## Product Change Notice (PCN)

**Subject:** Announcement of new marking layout of the listed Renesas Module device RAA210130\*

**Publication Date:** 4/18/2023

From (Existing)	To (New)
Marking

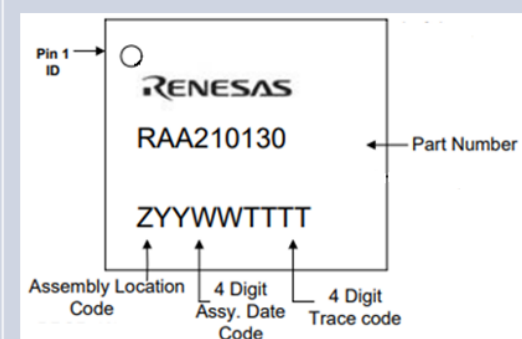
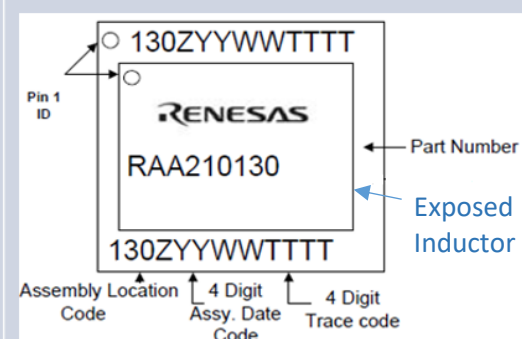
New marking template of the listed Renesas Module RAA210130\* device. Below summarizes the main changes:

1. Renesas Logo and Renesas Part Number were initially marked on the plastic package has changed to mark on the Exposed Inductor.
2. Assembly Location Code, Date Code and Trace Code are marked twice at the top left and bottom left corner of the package surface.
3. There are two (2) PIN 1 ID on the package surface for Renesas Product PIN 1 and Exposed Inductor PIN 1 respectively. Renesas Product PIN 1 that is located at the top left corner of the package surface shall prevail in all cases.
